ALERT SERVICE BULLETIN

DOORS - Sliding door - Sliding door opening mechanism

Revision No.	Date of issue
Revision 0	2018-12-10

Following the in-flight loss of a sliding door on an EC130 B4 helicopter, Airbus Helicopters makes it mandatory to check the load required to unlock the sliding door opening mechanism.

Figure 1

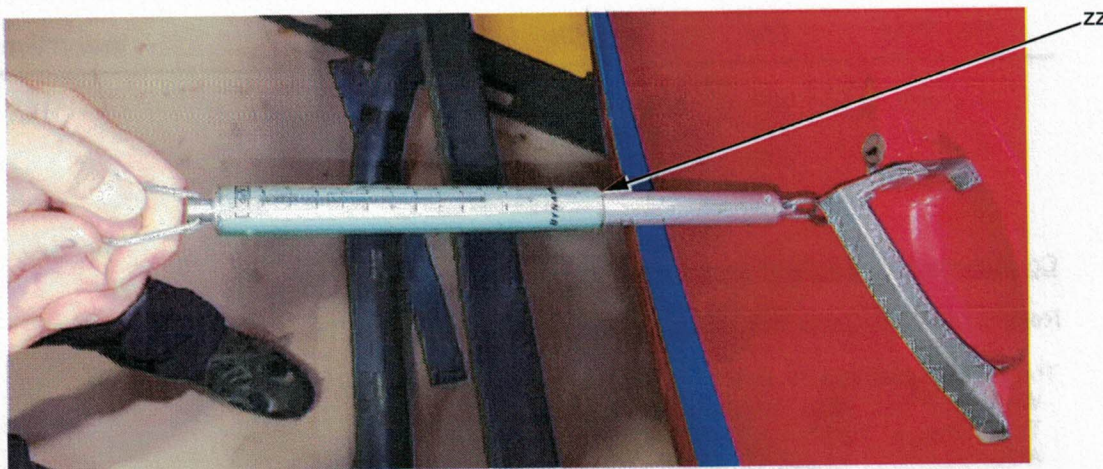
- With spring scale (zz) and **as per Figure 1**, measure the load required to operate the sliding door opening mechanism by pulling the external handle of the sliding door.

- . If the load required to operate the sliding door opening mechanism **is greater than or equal to 4 daN** (9 lbf):
 - .. If missing, trace a mark on both attachment screws (d) **as per Detail B of Figure 2**.
 - .. Comply with paragraph **3.C.** and continue flights.
- . If the load required to operate the sliding door opening mechanism **is strictly less than 4 daN** (9 lbf):
 - .. Adjust the rear upper LH catch of the sliding door as per paragraph **3.B.2**.

The adjustment is considered correct and the marks traced when the measured load required to operate the sliding door opening mechanism is greater than or equal to 4 daN (9 lbf).

Figure 2

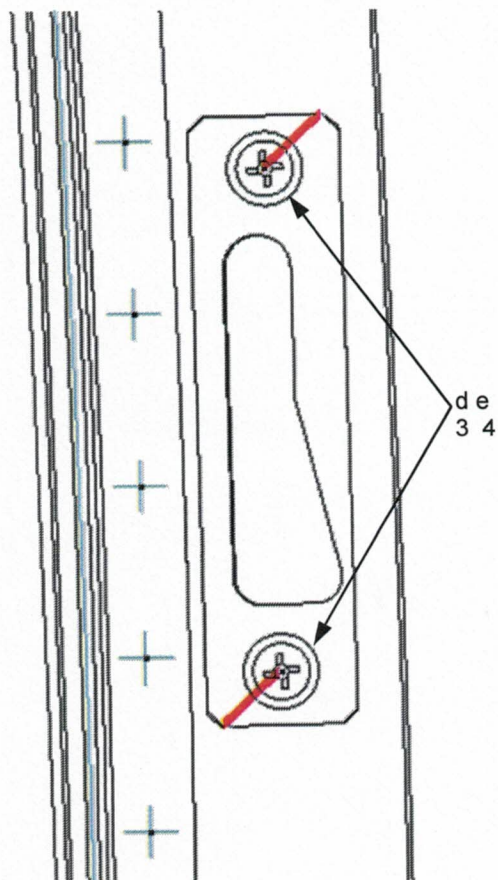
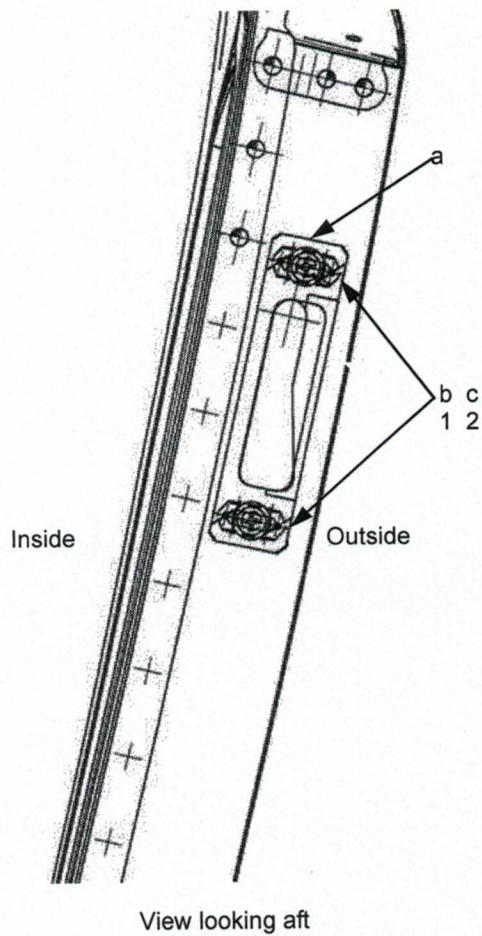
- Delete the marks, if any.
- Loosen attachment screws (d) (Figure 2) without removing them.
- Relocate rear LH upper catch (a) to the inside of the helicopter as per AMM Task 52-12-00, 5-1.
- Tighten attachment screws (d).
- With spring scale (zz) and as per Figure 1, measure the load required to operate the sliding door opening mechanism as per paragraph [3.B.1.](#)

- Visually check if the marks are aligned.

- Remove attachment screws (d) and washers (e), (Figure 2).
- Remove rear LH upper catch (a).
- Make sure that there is no sealant between rear LH upper catch (a) and the helicopter airframe.

- Remove attachment screws (d) and check their condition, (Detail B, Figure 2).
- Remove washers (e) and check their condition.
- Remove rear LH upper catch (a), (Detail A, Figure 2).
- Remove and discard rivets (c) and anchor nuts (b).
- Install anchor nuts (1) with rivets (2).
- Install rear LH upper catch (a) with washers (e) or (4) and attachment screws (d) or (3).
